F RSTECH, LLC. SUPPORT - 1(888) 820-3690, EXT. 203

Overview: The initial production release of the FTI-TLK1 harness has an issue where in some vehicles the secondary power input to the CN1 connector will overload the associated vehicle circuit, causing a fuse to blow. This issue affects the initial release of harnesses and is already being addressed in production. A field correction procedure is detailed below in Figure 1.

FTI-TLK1 Type 2B1 - Vehicle Coverage & Preparation Notes

Figure 1: Step by step adapter correction

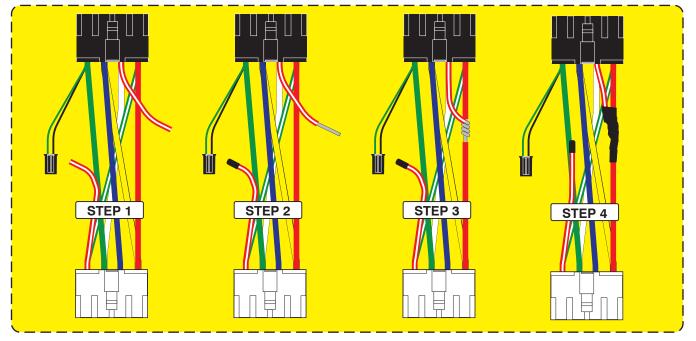
Issue: The secondary power circuit can overload some vehicle ignition switch circuits, causing a blown 5A/7.5A AM1 fuse, potentially disabling the vehicle and leaving the consumer stranded. Affected adapters are illustrated below in figure 2.

- 1.) Select the applicable CN1 adapter, isolate the RED/WHITE power wire, cut wire approximately 4" from the BLACK plug
- 2.) Insulate the wire still connected to the WHITE plug using heat shrink tubing, and strip the insulation on the other wire end
- 3.) Strip a portion of the insulation from the RED wire, attach the stripped RED/WHITE to the exposed RED wire, solder together
- 4.) Apply insulating tape to the soldered connection and secure the cut ends back to the bundle of wires created by the adapter
- 5.) Correction complete, you may safely proceed to finish your installation
